HSSD2 High speed fabric doors - 9500mm x 6000mm

TITLE	ALL DIMENSION ARE IN mm			NIHVA TECHNOLOGIES PVT. LTD.	NIHVA TECHNOLOGY PVT. LTD. PUNE Tel : 020 66304033 Email:– info@nihva.com Website:– www.nihva.com
STRUCTURE FOR MEGADOOR		SIGN	DATE		
	DRAWN	ABHIJIT	22/01/15	CLIENT -REWARD	
CLIENT APPROVAL	CHECK	ANIL	22/01/15	PROJECT-IR PROJECT AHEMADABAAD	
	ENG			SITE -	
	APPRD.			DWG. NO. - NVA/REWARD/02/RE02	
	MFG			SCALE: 01	WT: SHEET: 01
	Ref. No.			If any queries contact : projects@nihva.com

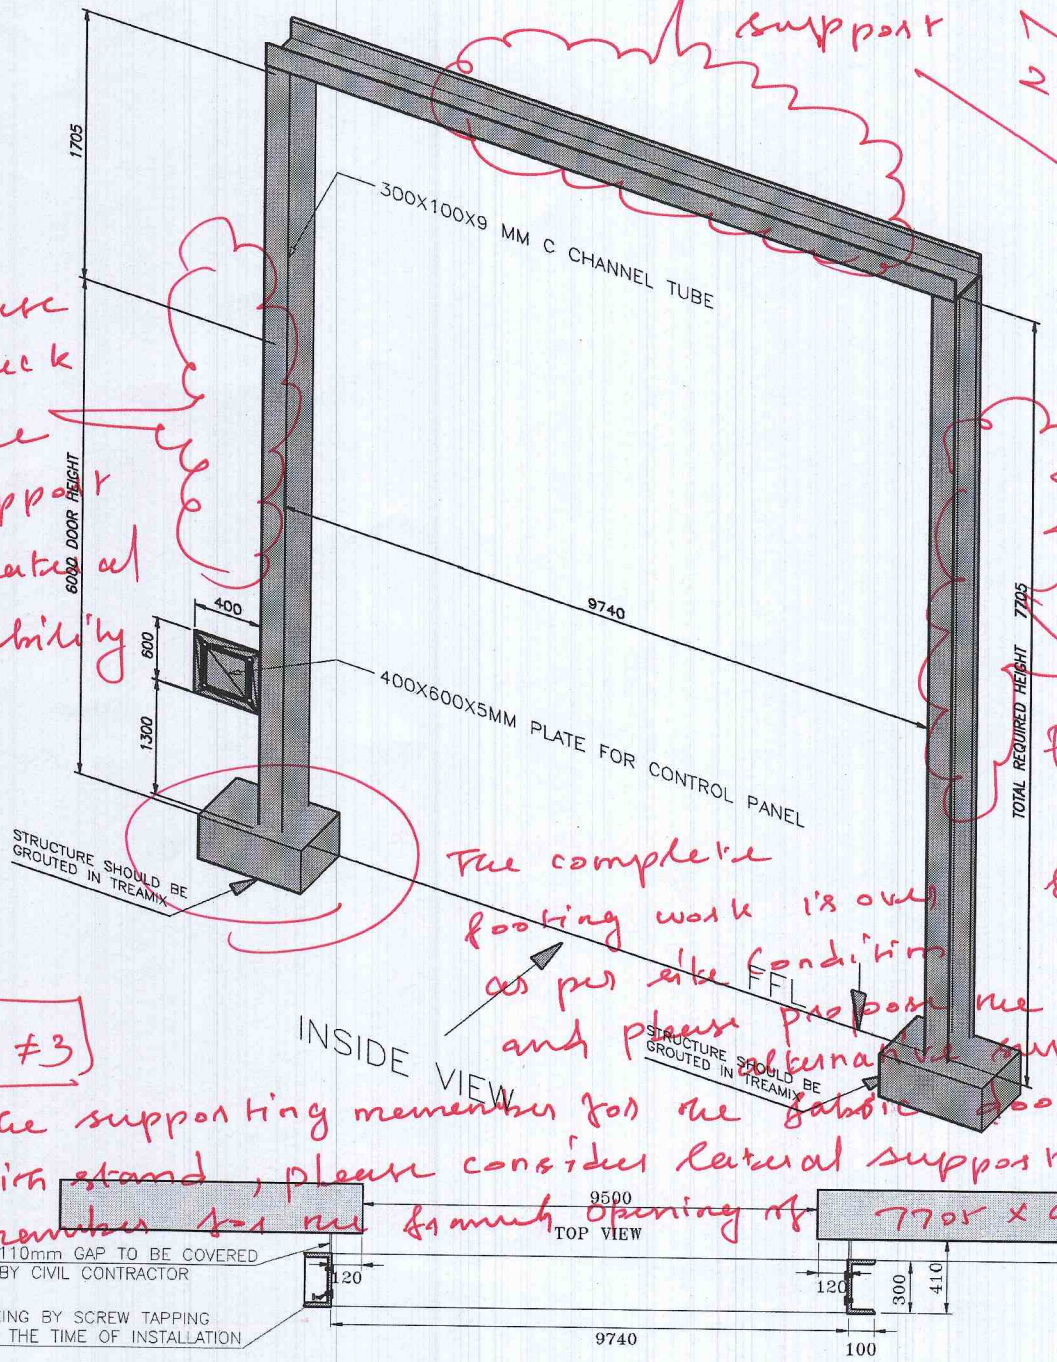
Please sheet ② of ②

Please support

Please check the support for lateral stability

Please check the support for lateral stability

The complete footing work is over as per site condition and please propose the alternate supporting arrangement

The supporting members for the fabric door will not with stand, please consider lateral supporting members for as much opening of 7705 x 9500 mm

structure should be bear approx. 7000 k.g. weight. (wind pressure included)
